PD Modification Application:

MM 25-0586 December 15, 2025

Development Services Department

1.0 APPLICATION SUMMARY

2.5 Proposed Site Plan (partial provided below for size and orientation purposes. See Section 8.2 for full site plan)

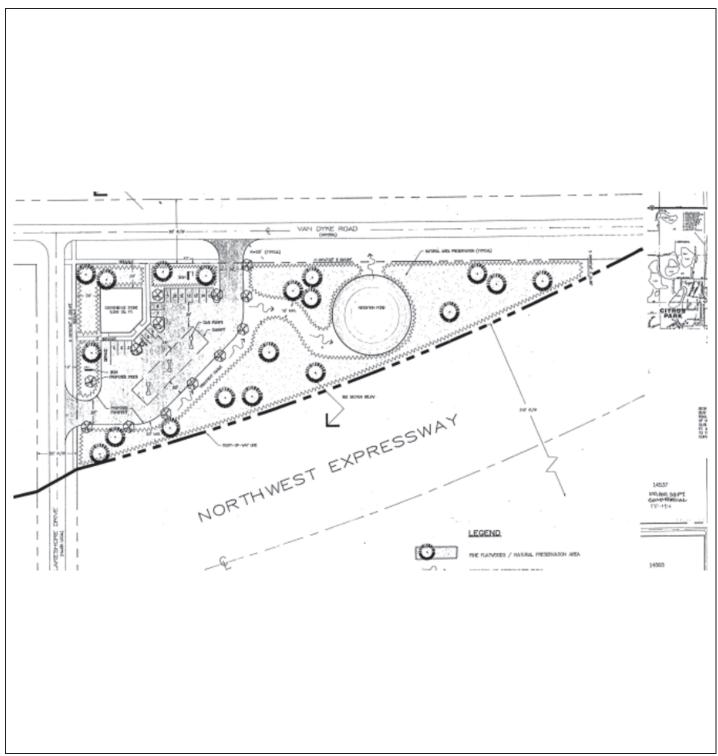
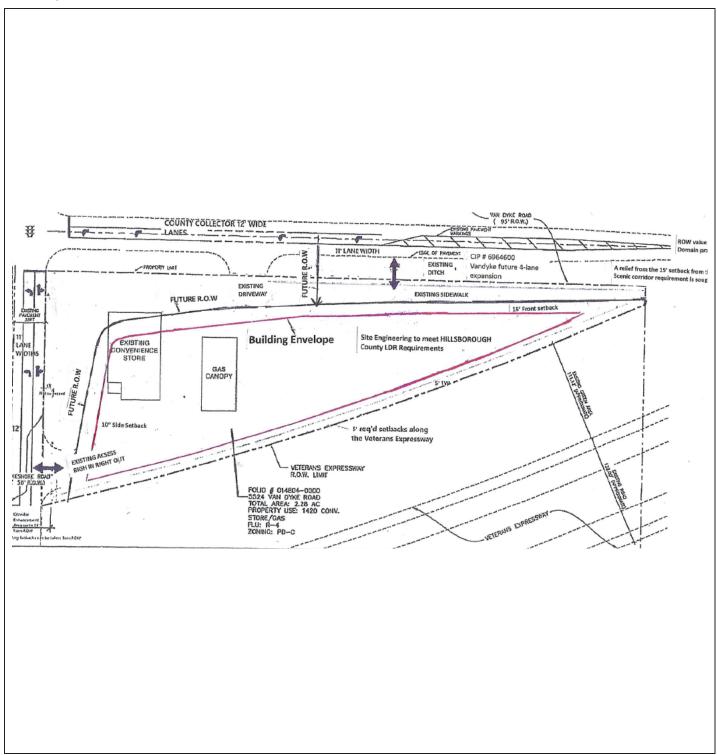
1. The site plan shall be revised to label the area between the existing right of way line and the future right of way as "Right of Way Preservation".

PD Variation Request:

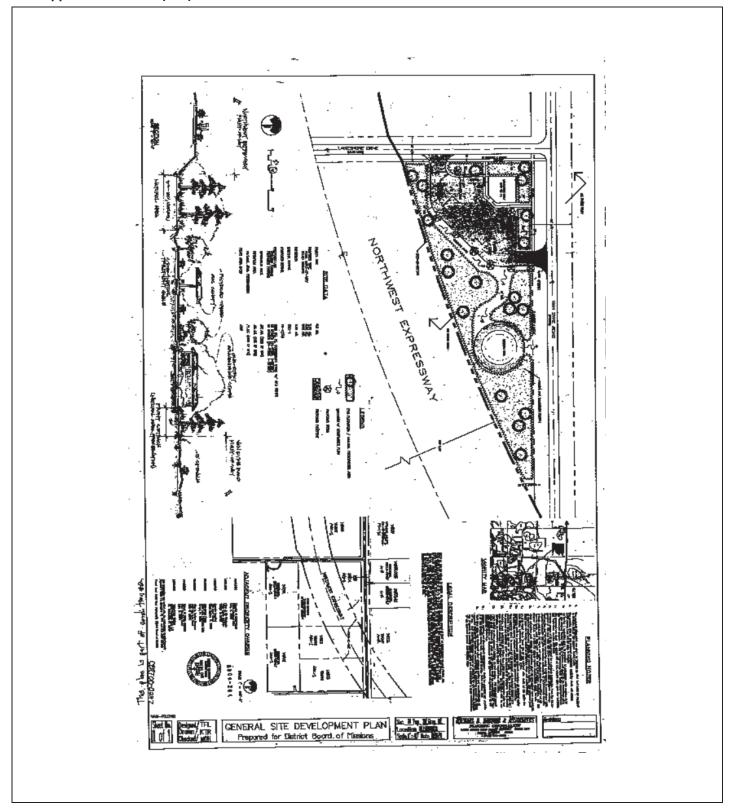
Van Dyke Road is classified as a Suburban Scenic Roadway requiring a buffer width of 15 feet with four canopy trees and four understory trees per 100 linear feet. Additionally, if street trees do not exist, one street tree per every 50 feet shall be provided. Van Dyke Road frontage is approximately 630 feet in length, which would require 25 canopy trees, 25 understory trees, and 12 street trees.

Per the applicant's responses, the site is a unique shape with three front yards – Van Dyke Road, Lakeshore Road and the Veteran's Expressway. The Hillsborough County Corridor Preservation Plan identifies this segment of Van Dyke Road as a future 4-lane roadway to include a round-about at the intersection with Lakeshore Drive and a 10-foot wide multi-use path on both sides. This reduces the area available to meet scenic corridor requirements. The proposed setback is equal to the scenic corridor buffer width of 15 feet.

Scenic Roadway regulations were adopted in 1994, subsequent to the original rezoning in 1992 and were originally based upon the zoning of the parcel, rather than the current practice of the future land use category of the parcel. The zonings of "Planned Development" were not contemplated.
